Reaz Knitwear Ltd.

Holding#163, Block-B, Hatimara, Kashempur, Gazipur
(23.990488, 90.298408)
11 September 2023

Observations

Lack of building permit

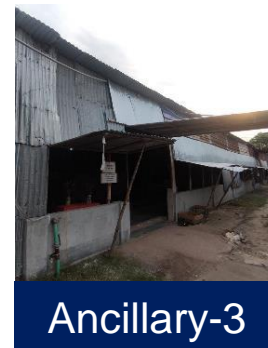
Building permit drawing was not available for the mentioned structure. The factory is required to collect building permit from BNBC prescribed local building permit authority.

Absence of design documents

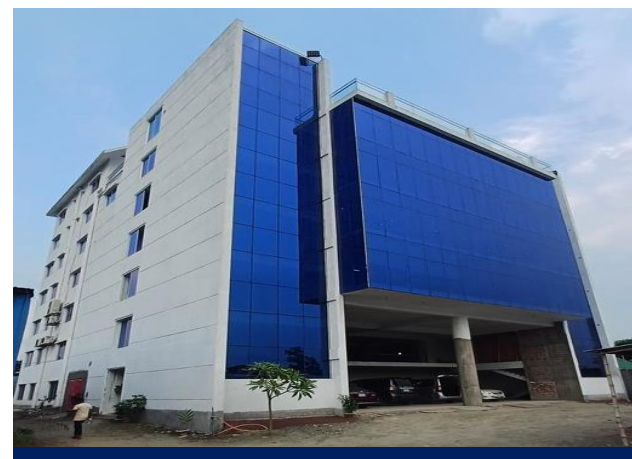
As per BNBC, every building or structure designed shall have its design documents prepared in accordance with the provision of Section 1.9.1, part-6 of BNBC. The design document shall include a design report, and a set of structural drawings, which shall be prepared in compliance with section 1.9.1.1 and section 1.9.1.2 as per BNBC. During inspection design report was not found which is required to be prepared in compliance with section 1.9.1.1 (part-6, BNBC).
